SB 187-18

Elite 6 Mid Lift Suspension Retaining Bolt Torque Check

Fig.1

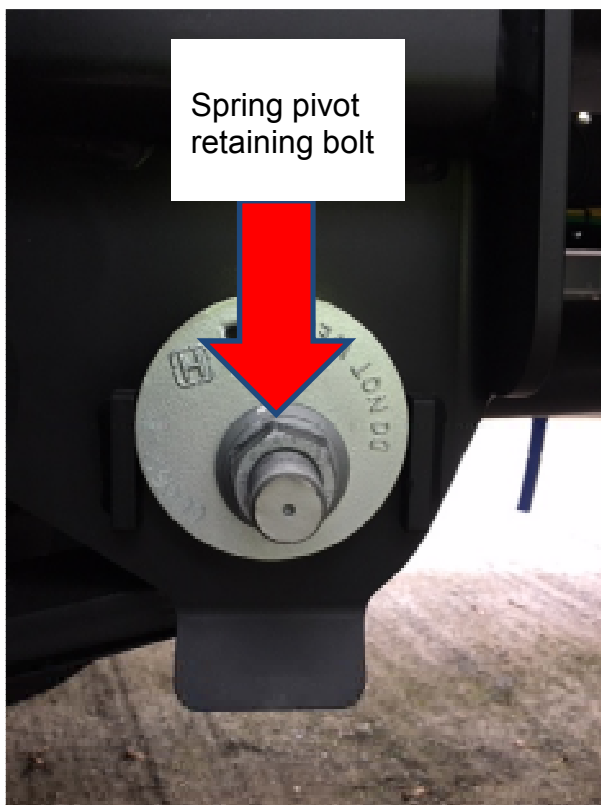
Dennis Eagle are asking all operators of Elite 6 trucks fitted with Hendrickson Mid Lift suspension using the spring pivot retaining bolt arrangement shown in Fig. 1 below to check the torque setting on the next vehicle inspection and thereafter once every twelve months.

The bolt pointed out in Fig. 1 should be torqued 600-700 Nm (443-516 lbf-ft).
